SAFETY EVALUATION BY THE OFFICE OF NUCLEAR REACTOR REGULATION
RELAXATION REQUEST FROM ORDER EA-03-009 REGARDING THE
BARE METAL VISUAL EXAMINATION OF THE REACTOR PRESSURE VESSEL HEAD
FACILITY OPERATING LICENSE NO. NPF-6
ENTERGY OPERATIONS, INC.
ARKANSAS NUCLEAR ONE, UNIT 2
DOCKET NO. 50-368

2.0 RELAXATION REQUEST FROM RPV HEAD BMV EXAMINATION, ORDER EA-03-009

Figure 4

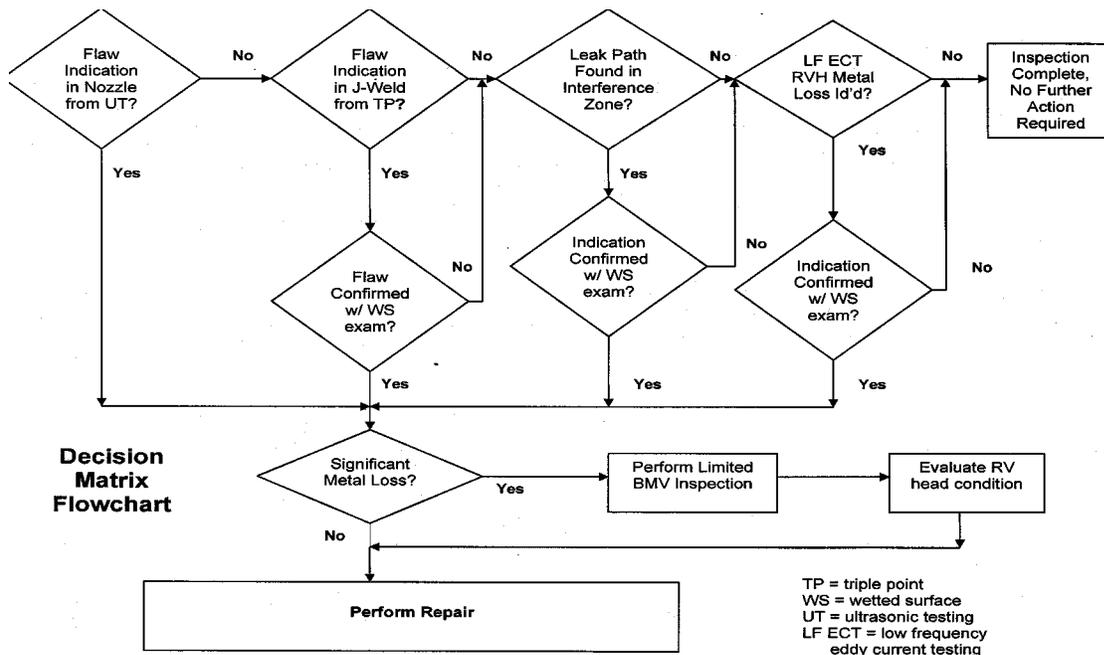
The staff reviewed the decision matrix (Figure 4) to determine if the application of the techniques proposed took into consideration the strengths and weaknesses of the alternatives proposed. The matrix requires that a LF ECT examination be performed after the evaluation of the leak path UT examination. This is an appropriate application of the technique, considering that published data indicates the leak path UT examination is not effective where no interference fit exists between the CEDM nozzle and vessel head penetration. Therefore, a gap must exist for the LF ECT to be an effective technique which, based on the discussion above, must exceed 0.125 inch.

The staff finds that the decision matrix provides a technically sound flowpath to determine if significant wastage exists.
